Rolling Knolls Landfill Superfund SITE

FIELD CHANGE REQUEST (FCR) FORM

REQUEST NO: 08 DATE: 06/09/2015 (revised 06/18/2015)

FCR TITLE: Replacement of MW-13 with Pore-water Samplers

FIGURE
1

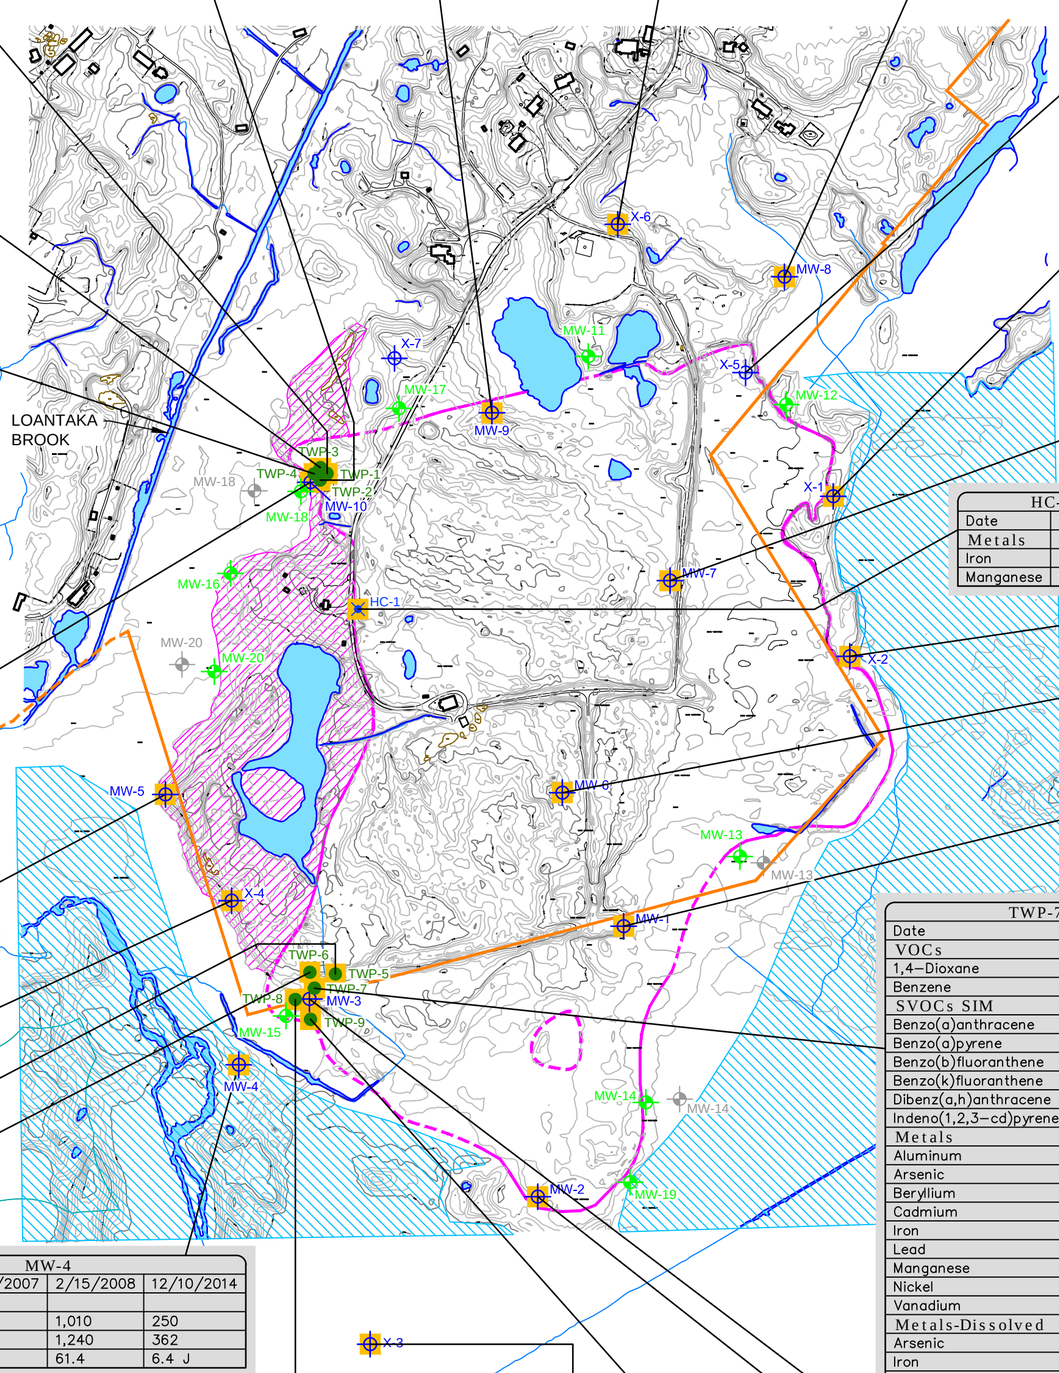
The Data Gaps Sampling and Analysis Plan (Data Gaps SAP) proposed installing seven permanent monitoring wells (MW-11 through MW-17). The Data Gaps SAP indicated the final locations of the permanent monitoring wells will be determined based on the results of the soil sampling and the temporary monitoring well samples collected as part of the data gap sampling. These data, and a proposal for the locations of the permanent monitoring wells, were transmitted to USEPA for review and approval on February 17, 2015. Additional supporting information was transmitted to USEPA on February 27, 2015. The USEPA responded on March 5, 2015 and requested adjustments to the locations of MW-12 and MW-15. The USEPA also requested the installation of three additional monitoring wells (MW-18 through MW-20). One of the proposed monitoring wells (MW-13) was to be located in an area later found to be inundated with water and is not a suitable location for a permanent monitoring well. Additional locations have been investigated; however, no appropriate relocation for this well has been identified. Consequently, the USEPA requested that pore-water samples be collected in place of this monitoring well.

Prior to installing the monitoring wells, ARCADIS personnel and a USEPA representative inspected each proposed monitoring well location. The proposed location for MW-13 was in approximately 6 to 24 inches of standing water. The location could not be moved to an area with no standing water, while still meeting the objective of delineating soil sample results from SS-157 and SS-158. USEPA was informed of these field conditions on May 28, 2015. As a result, on June 4, 2015, the USEPA requested pore-water samplers be placed at the MW-13 location, shown in green on Figure 1.

Monitoring well MW-13 will be replaced with porewater samplers. Regenerated cellulose membrane samplers will be used to collect volatile organic compounds (VOCs), metals (unfiltered only) and cyanide. Additional pore-water will be collected using PushPoint techniques and analyzed for semi-volatile organic compounds (SVOCs), pesticides, and polychlorinated biphenyls (PCBs) (as Aroclors). Certain SVOCs will be analyzed by SIM to obtain a lower detection limit. Sampling procedures will follow those approved in the Quality Assurance Project Plan (approved by USEPA on December 18, 2014) using standard operating procedures (SOPs) 20 and 21. If the pumping rate in the PushPoint samplers is low, it may be difficult to retrieve all the required volume for sample analysis within a sampling period of one 12-hour field day. In that case, the following order of priority for analyses will be used, as listed in Table 1 of the Data Gaps SAP for previously proposed pore-water samples (approved by USEPA on November 18, 2014) unless otherwise noted:
